Work Order ID 112790

Item Name: Fwd Crossfube

DESIGN	97	DART AEROSPACE LTD	
DRAWN	RF	HAWKESBURY, ONTARIO, CANADA	
CHECKED	CP	DRAWING NO.	REV. C
MFG. APPR.	EP	D206-667-141	SHEET 4 OF 4
APPROVED	MP	TITLE	SCALE
DE APPR.	MP	CROSSTUBE ASSY (206B HIGH FWD)	NTS
DATE	08.11.06	COPYRIGHT © 2000 BY DART AEROSPACE LTD THIS DOCUMENT IS PRIVATE AND CONFIDENTIAL AND IS SUPPLIED ON THE EXPRESS CONDITION THAT IT IS NOT TO BE USED FOR ANY PURPOSES OR COPIED OR COMMUNICATED TO ANY OTHER PERSON WITHOUT WRITTEN PERMISSION FROM DART AEROSPACE LTD

DRAWING NO. D206-667-141	TITLE CROSSTUBE ASS'Y (206B HIGH FWD)	REV. C	DART AEROSPACE LTD ENGINEERING ORDER		D.E.O. NO. D206-667-141-C-1	SHEET NO. SHEET 1 OF 1	SCALE NTS
DRAWN <i>q</i>	CHECKED <i>ASS</i>	MFG. APPR. <i>MD</i>	APPROVED <i>MD</i>		DE APPR. <i>MD</i>		
DATE 11.07.15	DATE 11.07.20	DATE 11.07.21	DATE 11/07/21		DATE 11.07.21

DRAWING NO. D206-667-141	TITLE CROSSTUBE ASS'Y (206B HIGH FWD)	REV. C	DART AEROSPACE LTD ENGINEERING ORDER		D.E.O. NO. D206-667-141-C-2	SHEET NO. SHEET 1 OF 1	SCALE NTS
DRAWN AJS	CHECKED	MFG. APPR.	APPROVED		DE APPR.		
DATE 12.08.02	DATE 12.08.02	DATE 12.08.02	DATE 12.08.02		DATE 12.08.02

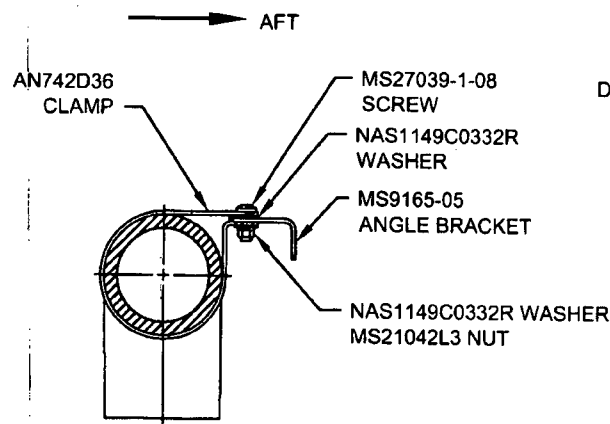
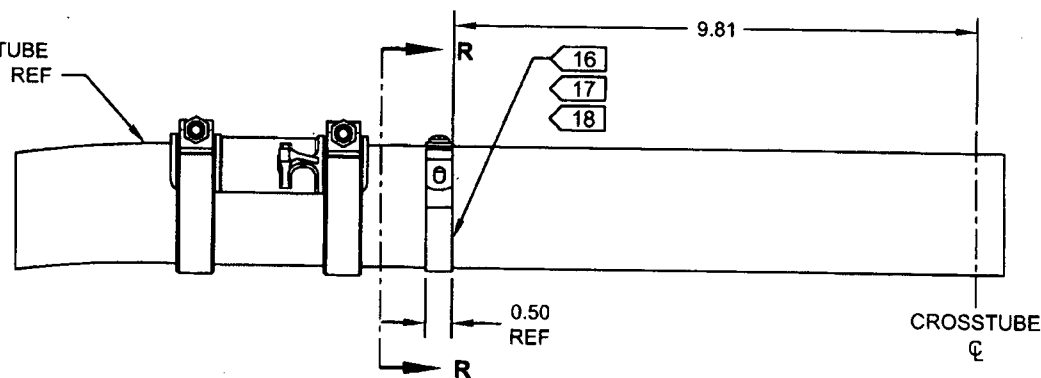
ADD ELECTRICAL GROUNDING STRAP

DETAIL P
BONDING STRAP INSTALLATION*2 PL

ITEM	QTY -141	PART NUMBER	DESCRIPTION
1	X	D206-667-141	CROSSTUBE ASSEMBLY (206B HIGH FWD)
10	2	AN742D36	CLAMP
11	2	MS9165-05	ANGLE BRACKET
12	2	MS21042L3	NUT (OR MS21042-3)
13	2	MS27039-1-08	SCREW
14	4	NAS1149C0332R	WASHER (OR AN960C10L)
